**ADDENDUM NO.:** 2

**Description:** Furnish, Deliver and Install Auto and Video Equipment

**Project:** 3783309999

**Specifics of the Addendum:** Respond to Questions received during the Request for Information period.

**1 ROOM 501 & 510 NEW SYSTEM - AV SIGNAL FLOW (TYPICAL OF 2)**  
SCALE: NTS

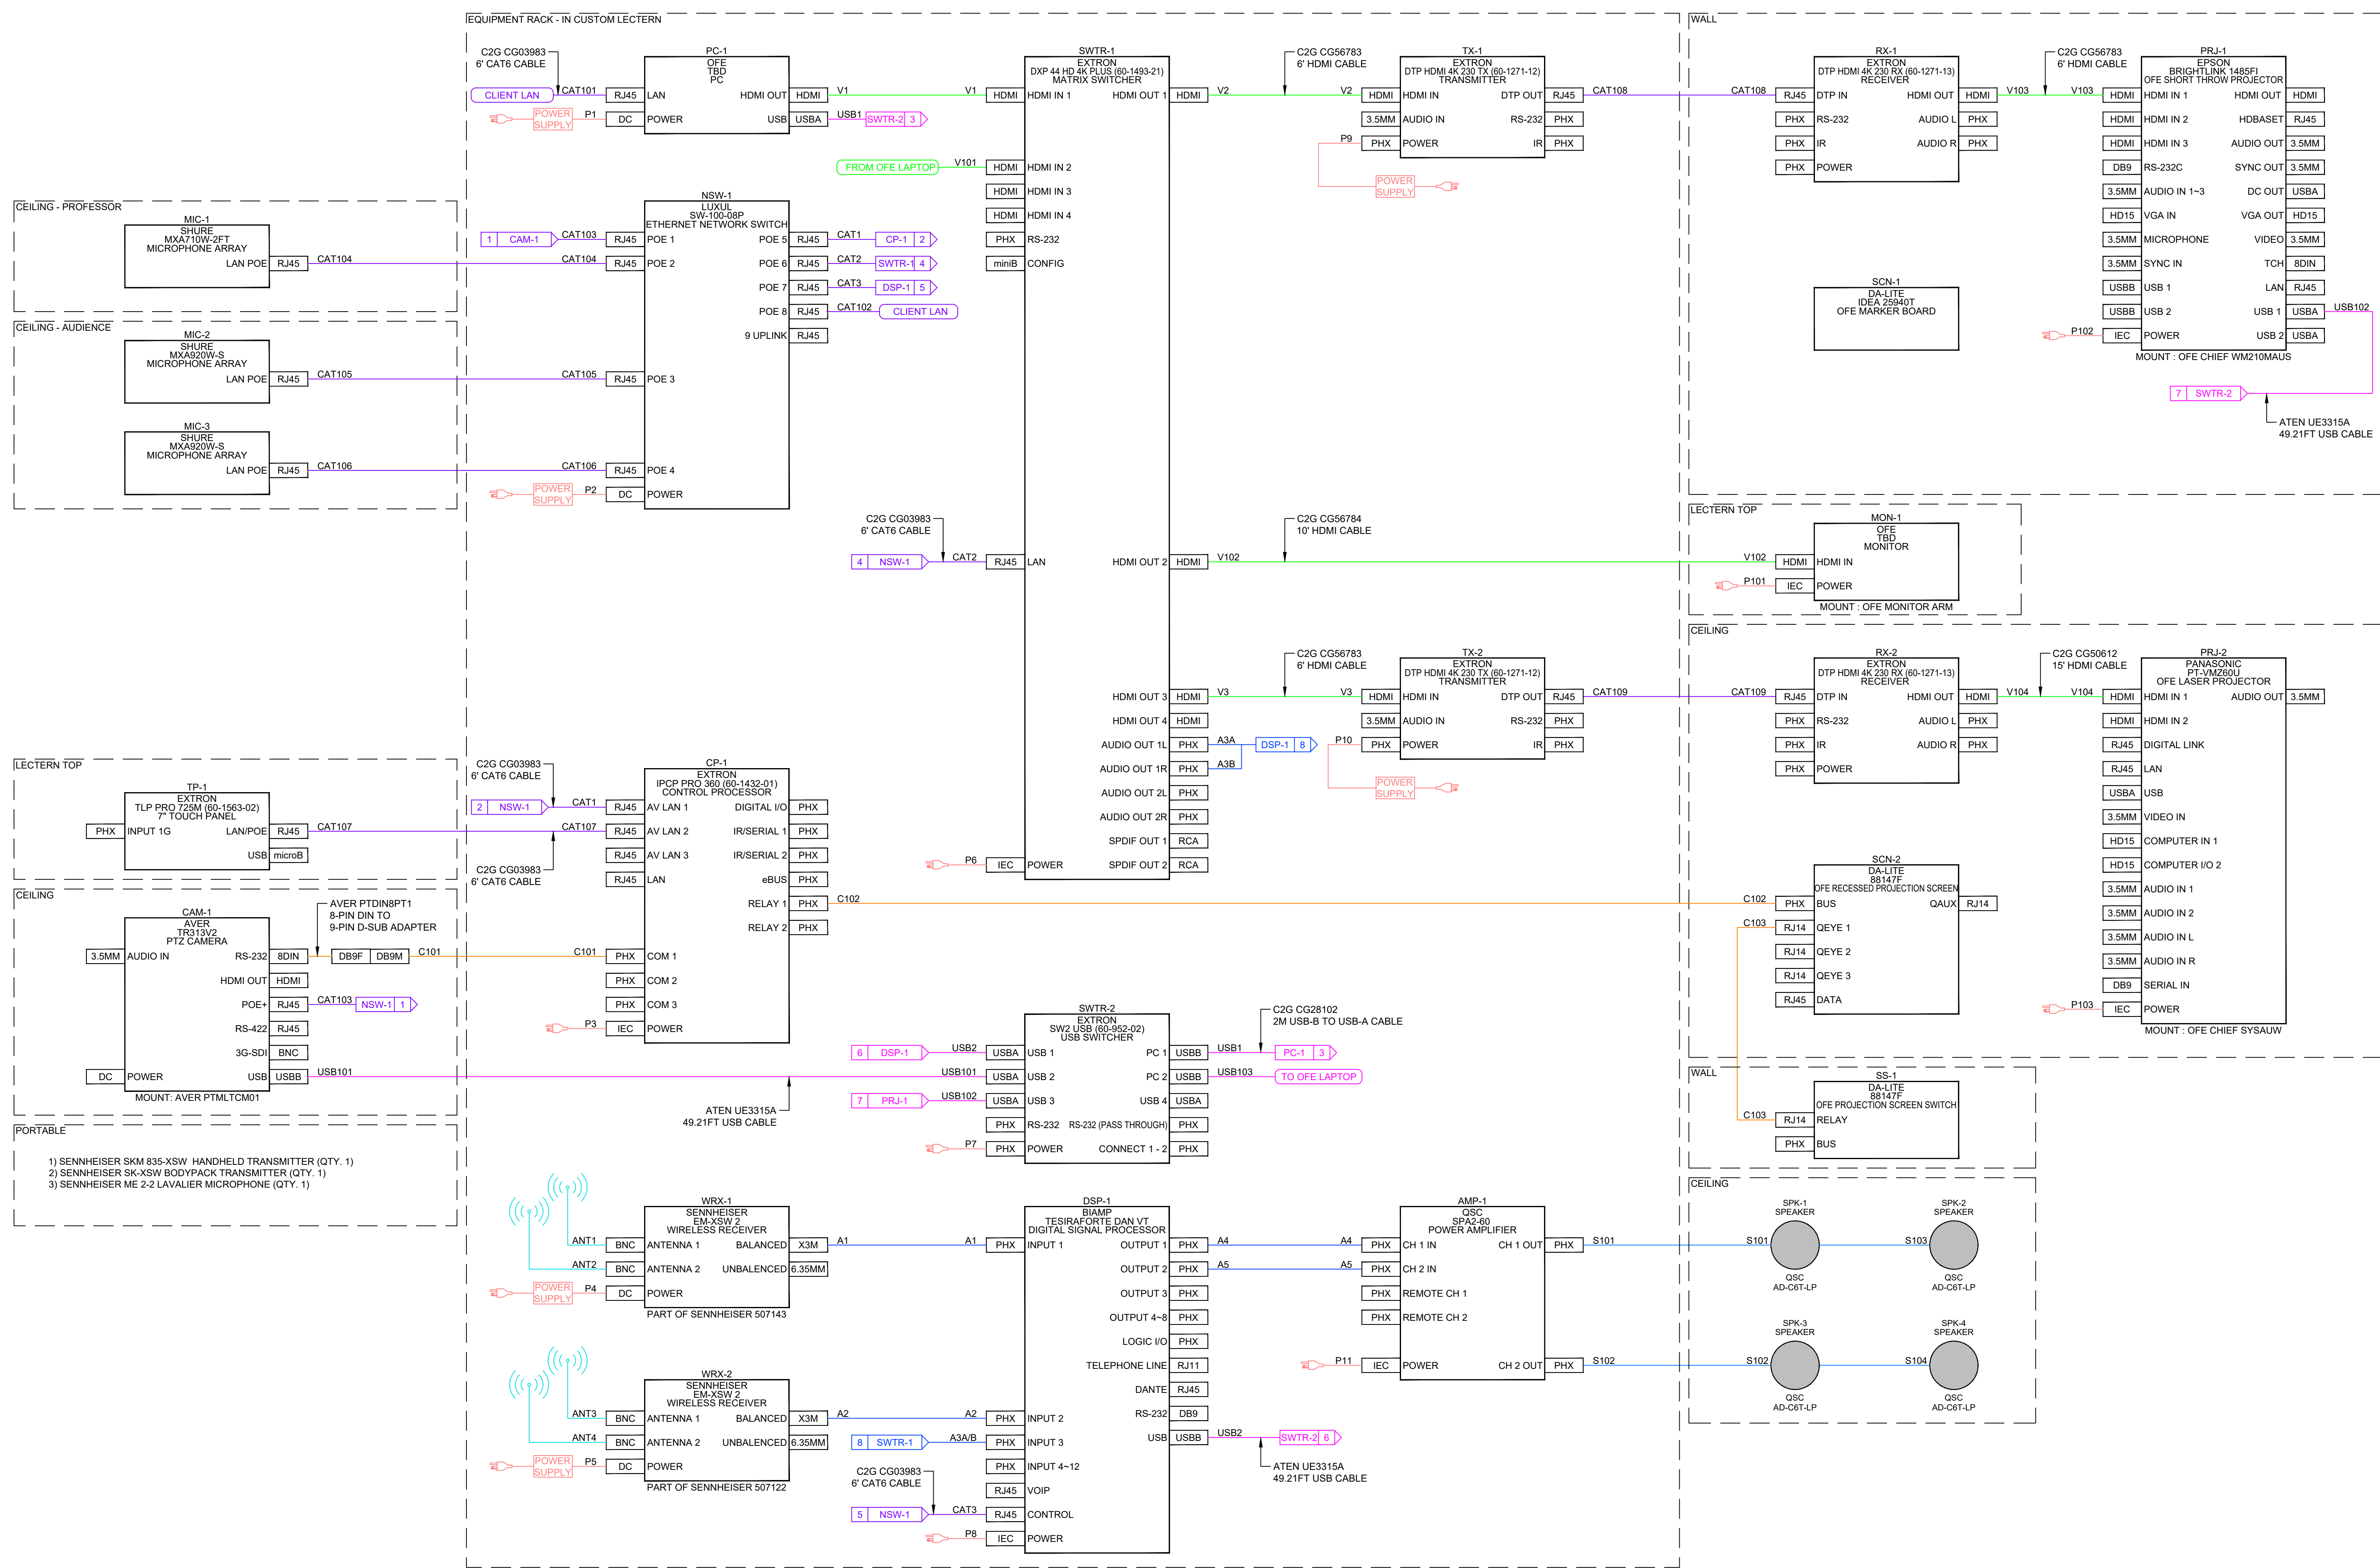
Q1. Is there a wiring diagram available for this project?

Q2. Do you by any chance know who spec'd out the gear and are there any signal flow drawings for the Extron equipment?

- Q6. Can CUNY/Guttman be supplying the AV wiring diagram for the “mock-up” room we visited on the 5<sup>th</sup> floor during the walk-through? This will show how the existing system is being wired “point-to-point”.

A1. Wiring diagram is attached.

A2. Our client worked with Extron providers to determine the required equipment. A list of the required equipment is part of the detailed specs. Wiring diagram is attached.

- A6. Wiring diagram attached.
- Q7. Will CUNY/Guttman be supplying the existing Touch Panel control program so it can be duplicated in the new rooms? This is an Extron control system.
